SIB 61 23 20

2022-04-28

RECALL 20V-601: HIGH-VOLTAGE BATTERY RECALL

This Service Information Bulletin (Revision 10) replaces SI B61 23 20 **dated April 2021**.

SP44 HV Battery (G05) modules-

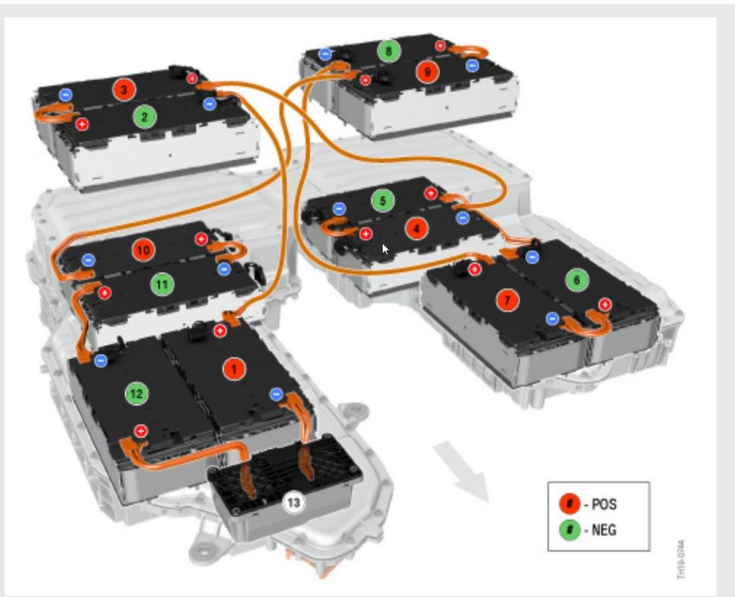
G05 modules (SP44 HV battery) are:

NEG (01) or POS (02)

Use EPC diagram to verify the correct module part number (01/02) for NEG or POS modules.

Use the illustration on the right to match the part# with the correct module installation location.

- Module 12 is **NEG (01)**
- Module 1 is **POS (02)**
- Module 11 is **NEG (01)**
- Module 10 is **POS (02)**
- Module 2 is **NEG (01)**
- Module 3 is **POS (02)**
- Module 8 is **NEG (01)**
- Module 9 is **POS (02)**
- Module 5 is **NEG (01)**
- Module 4 is **POS (02)**
- Module 6 is **NEG (01)**
- Module 7 in **POS (02)**

SP41 HV Battery (G01/G20/G20/G12) modules-

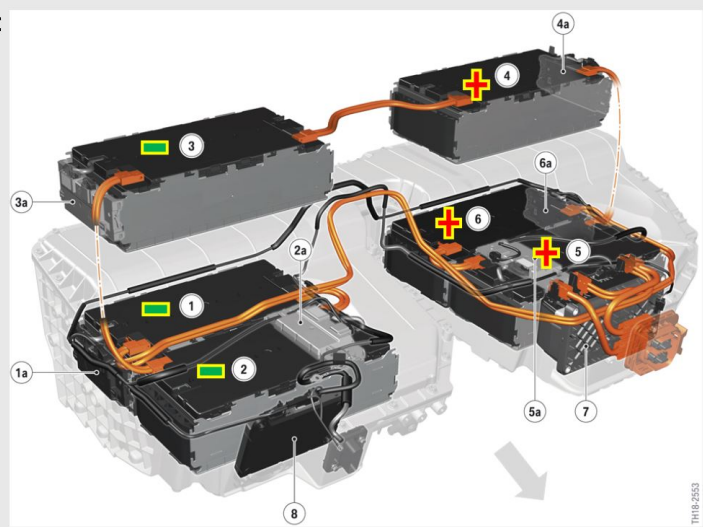
G01/G20/G30/G12 LCI modules (SP41 battery) are:**NEG (01) or POS (02)**

Use EPC diagram to verify the correct module part number (01/02) for NEG or POS modules.

Use the illustration on the right to match the part# with the correct module installation location.

- Module 1 is **NEG (01)**
- Module 2 is **NEG (01)**
- Module 3 is **NEG (01)**
- Module 4 is **POS (02)**
- Module 5 is **POS (02)**
- Module 6 is **POS (02)**
